RE: Gallatin County Alternative School & Field House
Gallatin County, Kentucky
BG 12-133
RTA 0914

A meeting was held Wednesday, April 10th in the construction trailer and the items below (and attached) are items reviewed and discussed in the meeting.

April 11, 2013

An observation was made Wednesday April 10th as noted below. Weather was sunny and in the low 80's.

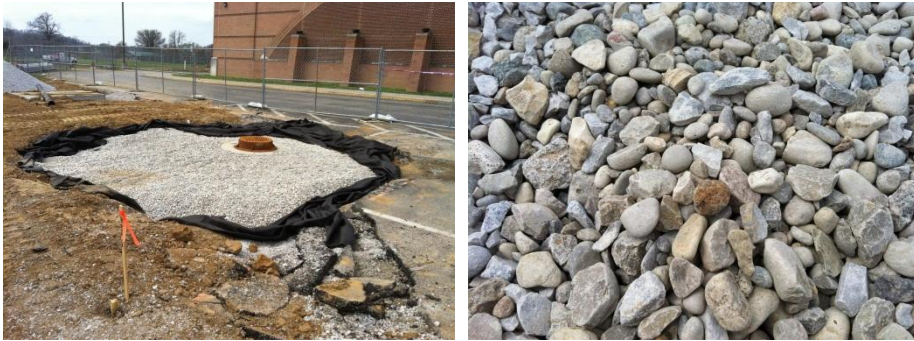
4. Electrical conduit was being installed to Park Road.
